It is requested to relocate the Comm & Operations Bldg, and Security Control Bldg, including Parking Lot & Paved Road for the following reasons

Attached plan

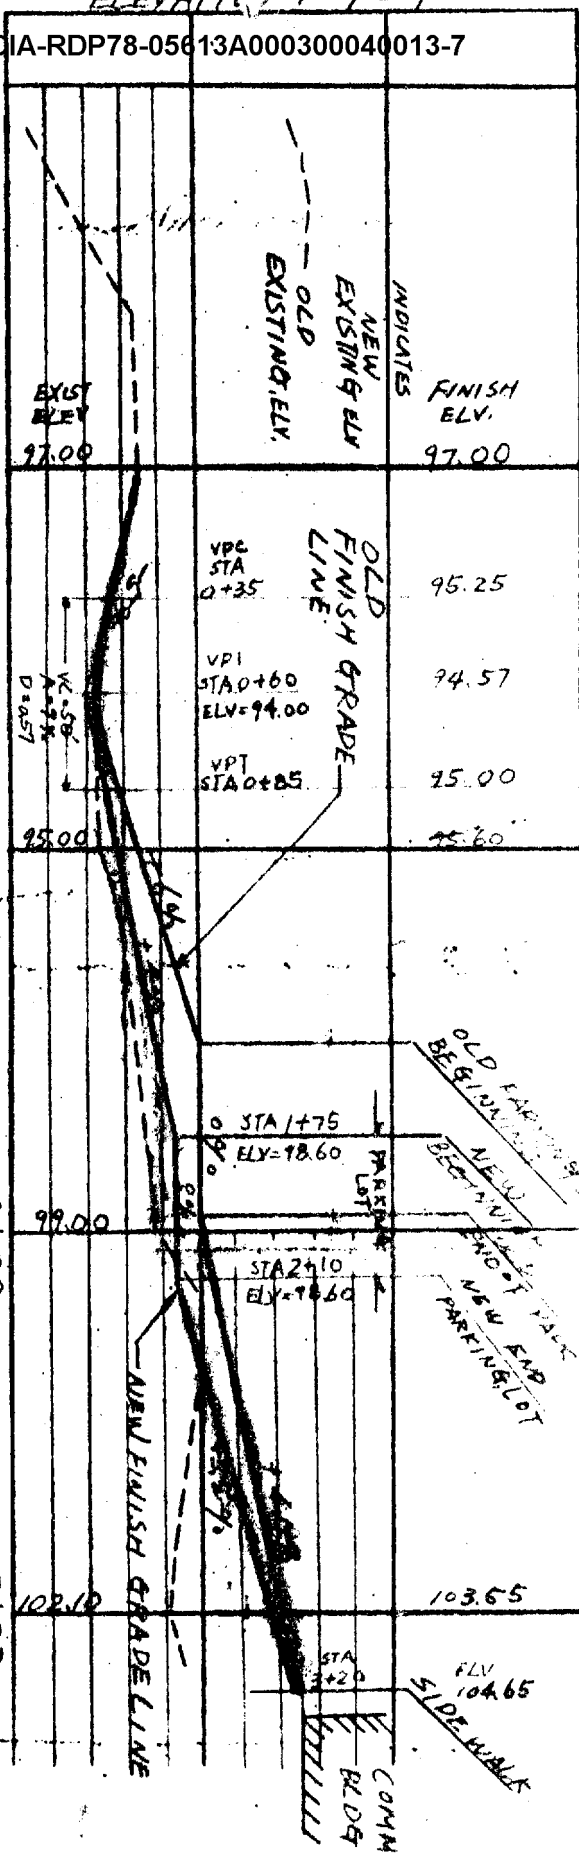
1. According to original plan, Comm & Operations Bldg will be constructed on the huge crag and a part of Bldg foundation will be filled at least (5) foot and it is recommended to relocate (7) foot to the North-east & South-east which will be the most proper ground to construct Bldg.
2. It is estimated to fill more than (7) foot where Security Control Bldg will be built and is considered to relocate (20) foot to the East where there is solid ground and there will be no inconvenience for use of the building
3. Also it is estimated to fill the Parking area and Paved Road which is considered improper to construct it on filled area and is requested to relocate as well as Security Control Bldg is relocated
4. The undersigned submitted the relocated plan and it is cordially requested to approve this request, Under the
